Symptom - Body Exterior - Filler Flap/Charge Port Door is Jammed/Stuck: Replacing filler flap/charge port door (SY 49/18)

Vehicle Type: **Panamera (97A/97B)** Sedan (not Sport Turismo models)

Subject: **Filler flap/charge port door**

*(Removing filler flap/charge port door)*

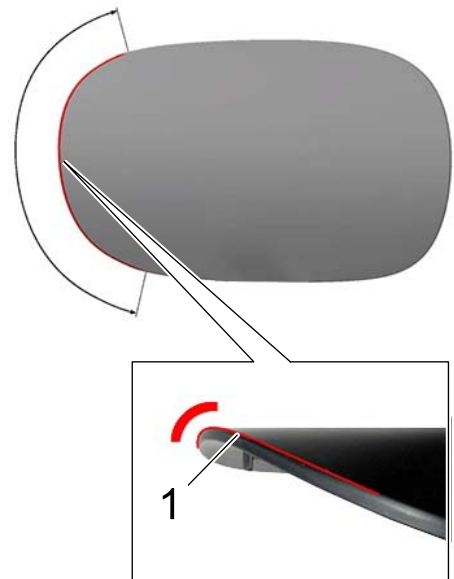
- 1.1 Open the filler flap/charge port door ⇒ *(Removing filler flap/charge port door) -2-*.
- 1.2 Release catch ⇒ *(Removing filler flap/charge port door) -1-* using a suitable tool and pull off filler flap/charge port door ⇒ *(Removing filler flap/charge port door) -2-* (⇒ *(Removing filler flap/charge port door) -arrow-*).

- 1.3 Paint new filler flap/charge port door ⇒ *(Removing filler flap/charge port door)-2-* in vehicle color.
- 1.4 Carefully push new filler flap/charge port door ⇒ *(Removing filler flap/charge port door)-2-* into the guides until it locks with an audible click.

(Edge on filler flap/charge port door)

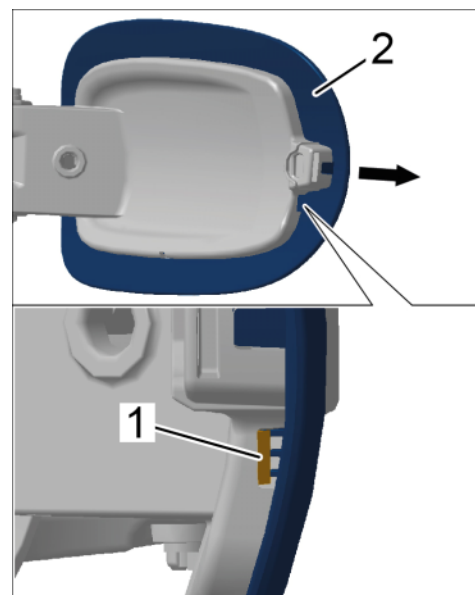
- There may be a visible and palpable edge on the upper side of the new filler flap/charge port door. In this case, remove the edge in the area marked in red ⇒ *(Edge on filler flap/charge port door)-1-* using suitable sandpaper.
